CITY OF ALBUQUERQUE

Re: Petroglyph Plumbing
3031 Painted Rock NW
Traffic Circulation Layout
Engineer's Stamp 12-22-22 (G10-D029)

Based upon the information provided in your submittal received 02-24-23, the above referenced plan cannot be approved for Building Permit until the following comments are addressed:

TRAFFIC CIRCULATION AND LAYOUT

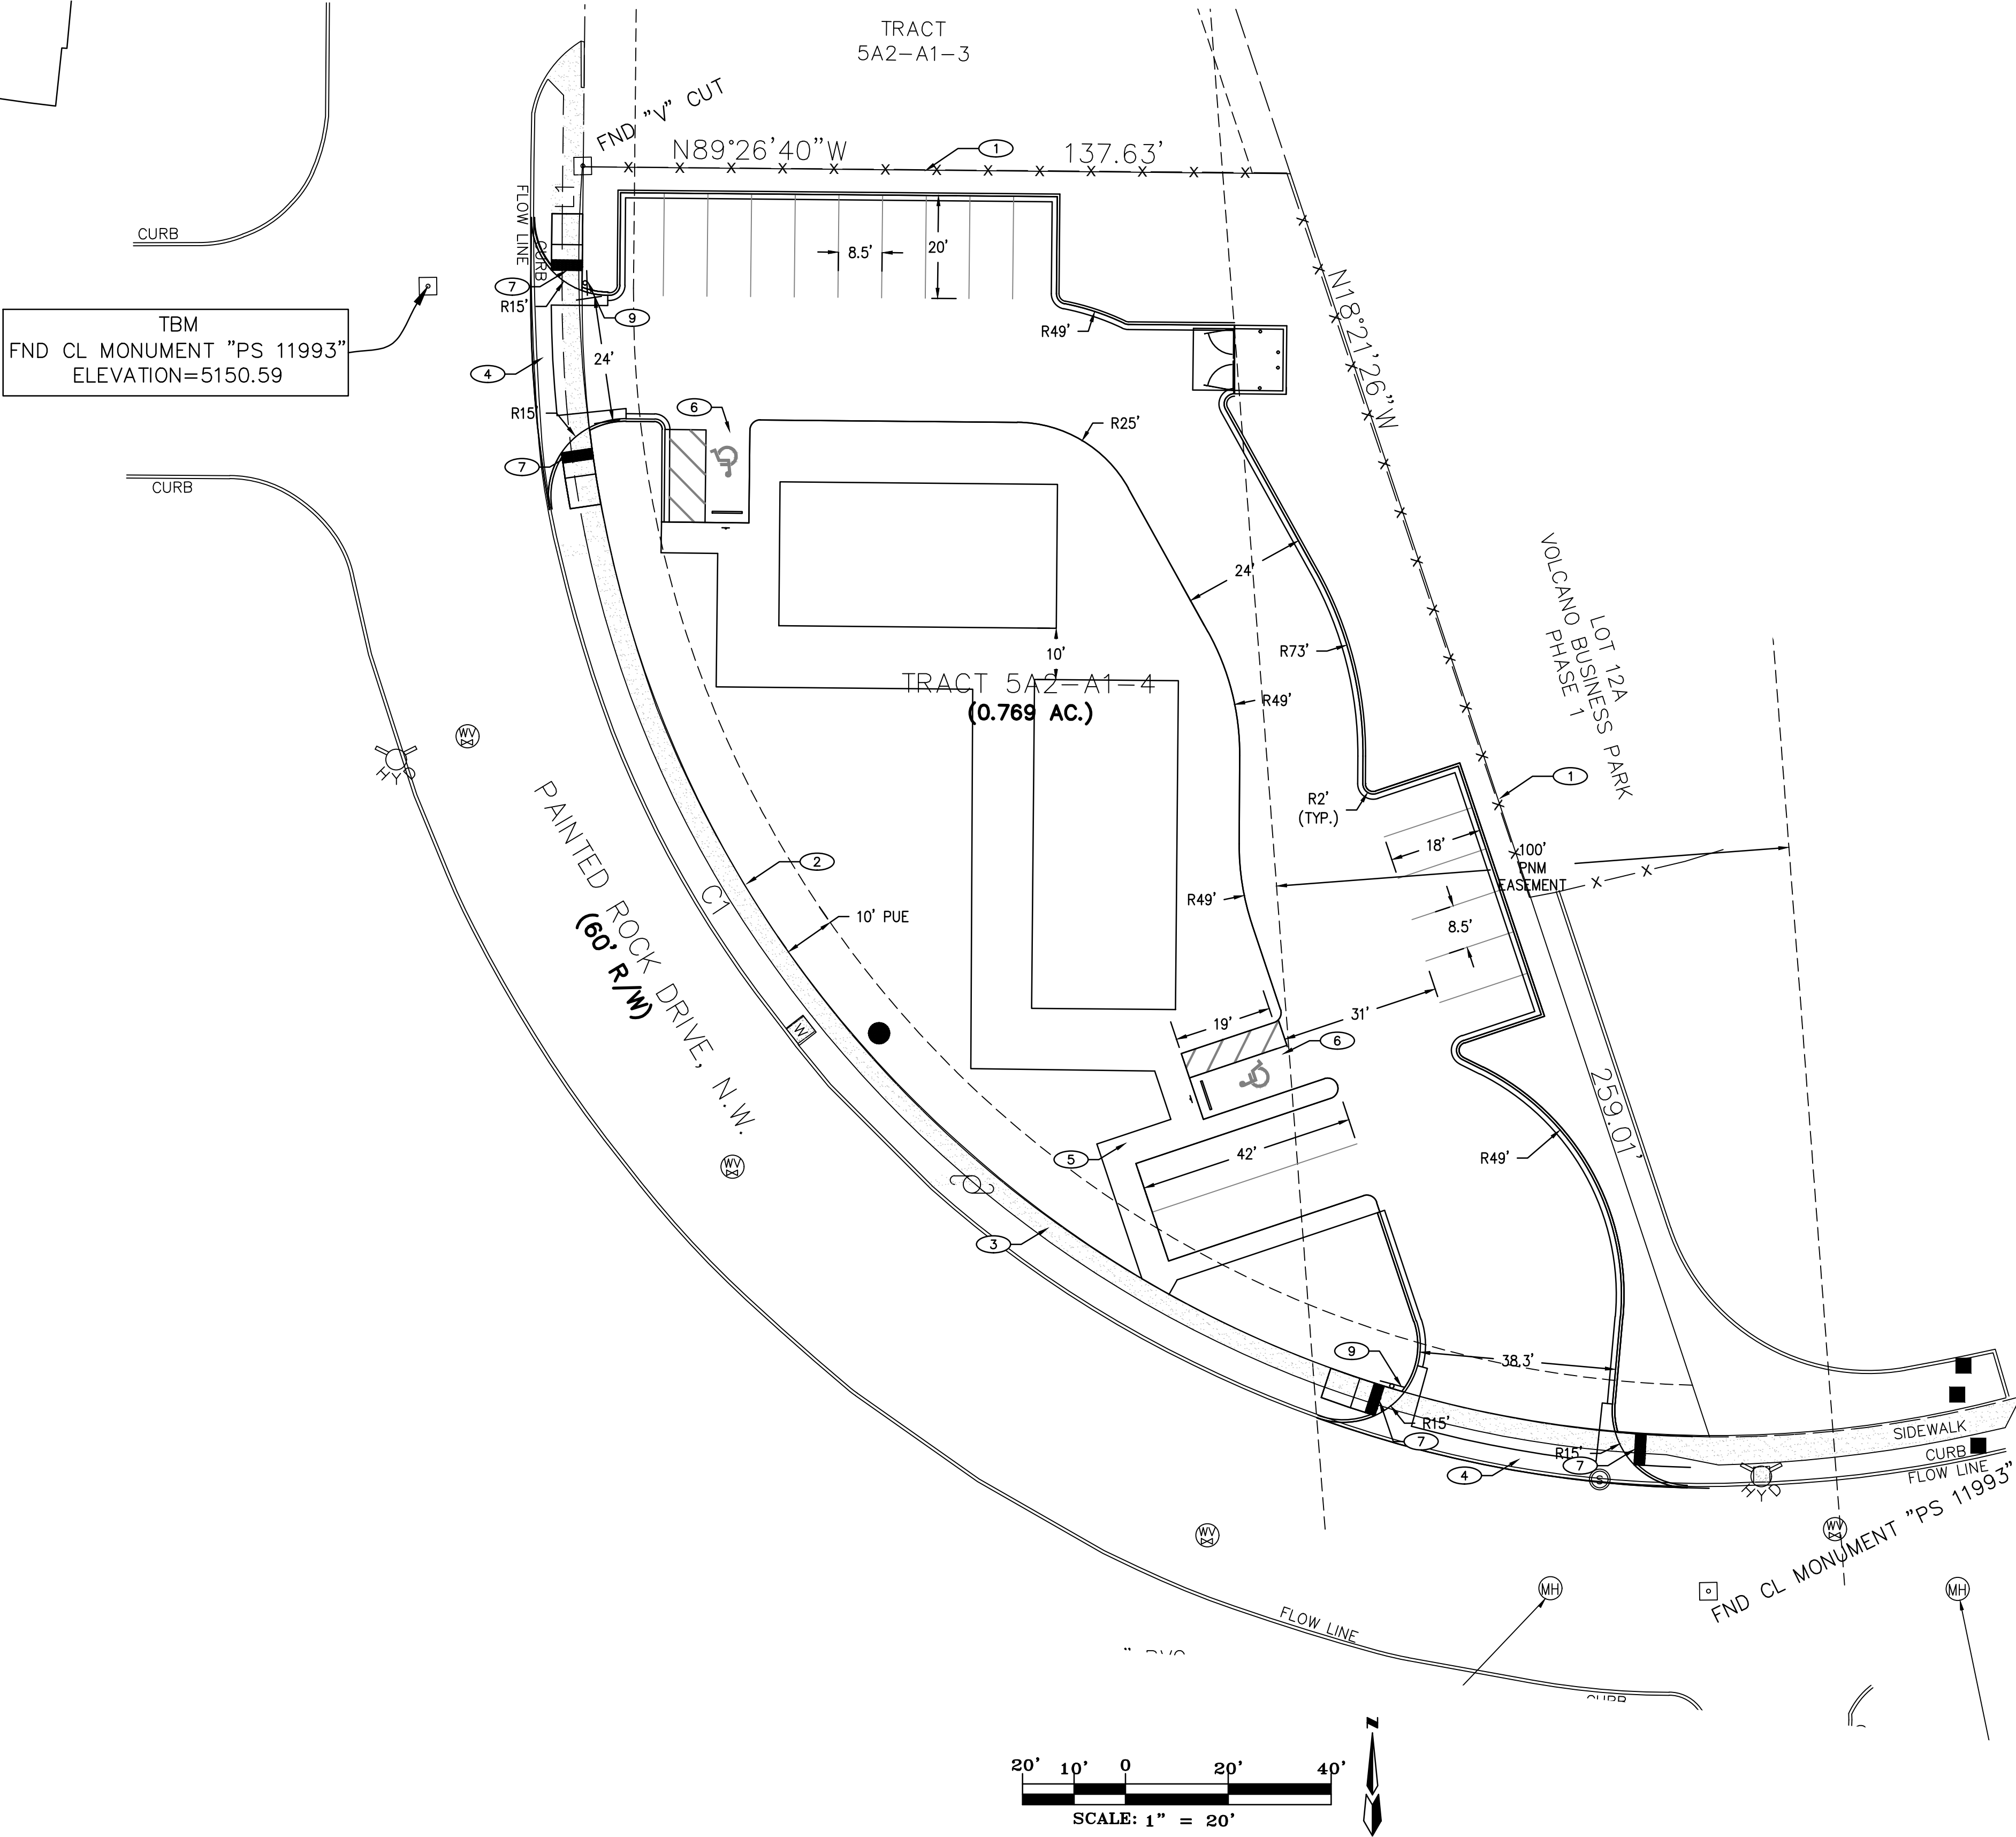
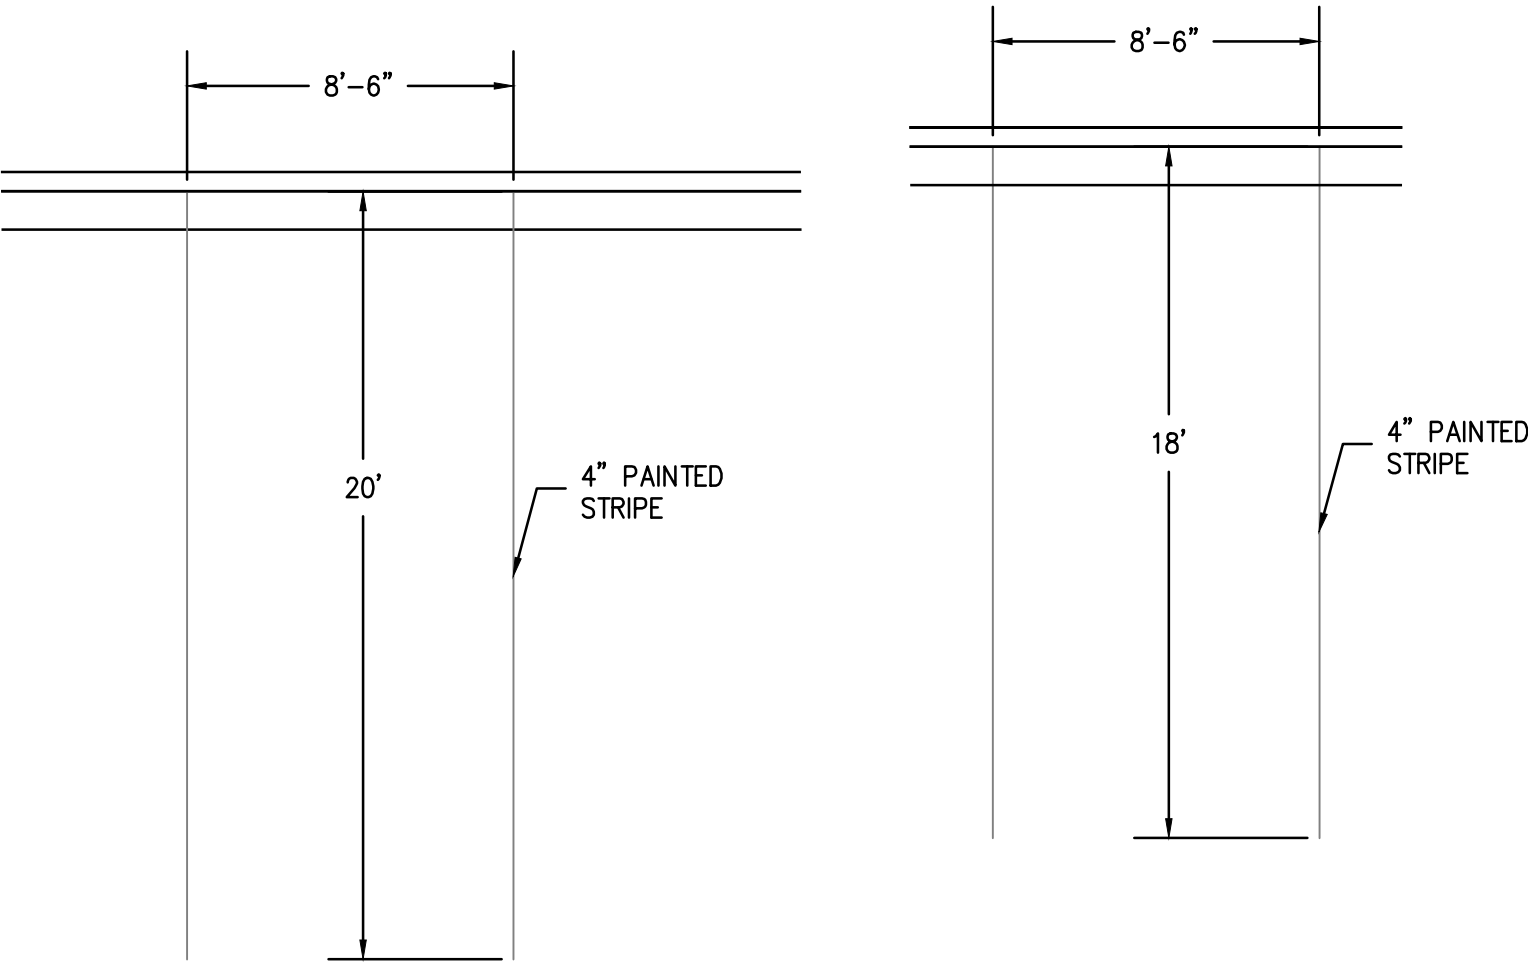
1. List the number of Motorcycle and Bicycle parking spaces required by.
2. Please define the property line.
3. Identify all existing access easements and rights of way width dimensions.

4. Motorcycle parking spaces shall be designated by its own conspicuously posted upright sign, either free-standing or wall mounted per the zoning code.

5. The pavement marking "MC" should be shown in the opposite direction for motorcycles entering the parking space.
6. All bicycle racks shall be designed according to the following guidelines:

- a. The rack shall be a minimum 30 inches tall and 18 inches wide.
 - b. The bicycle frame shall be supported horizontally at two or more places. Comb/toaster racks are not allowed.

- c. The rack shall be designed to support the bicycle in an upright position. See the IDO for additional information.
 - d. The rack allows varying bicycle frame sizes and styles to be attached.

- e. The user is not required to lift the bicycle onto the bicycle rack.
 - f. Each bicycle parking space is accessible without moving another bicycle.

7. Bicycle racks shall be sturdy and anchored to a concrete pad.
8. A 1-foot clear zone around the bicycle parking stall shall be provided.
9. Bicycle parking spaces shall be at least 6 feet long and 2 feet wide.

10. Per the IDO, a 6 ft. wide ADA accessible pedestrian pathway is required from the public sidewalk to the building entrances. Please clearly show this pathway and provide details.

11. Per DPM, a 6 ft. wide ADA accessible pedestrian pathway is required from the ADA parking stall access aisles to the building entrances. Please clearly show this pathway and provide details.

12. ADA accessible pedestrian pathway should not be placed behind parking space or adjacent to a vehicular way. Vehicle and pedestrian/wheel chair conflicts should be avoided as much as possible.

13. Curbing should be installed to delineate landscape, parking, and pedestrian ways and identify points of access. Please call out detail and location of barrier curb.

14. Refuse vehicle maneuvering shall be contained on-site. The refuse vehicle shall not back into the public right of way.; provide a copy of refuse approval.

15. Please provide a copy of Fire Marshal approval.
16. It is not apparent what type of pavement surface is being proposed. A hard driving surface will be required as part of this proposed project for parking area and drive aisles.

17. Show the clear sight triangle and add the following note to the plan: "Landscaping and signage will not interfere with clear sight requirements. Therefore, signs, walls, trees, and shrubbery between 3 and 8 feet tall (as measured from the gutter pan) will not be acceptable in the clear sight triangle.

18. Please specify the City Standard Drawing Number when applicable.
19. Add a note stating "All broken or cracked sidewalk must be replaced with sidewalk and curb & gutter." A build note must be provided referring to the appropriate City Standard drawing.
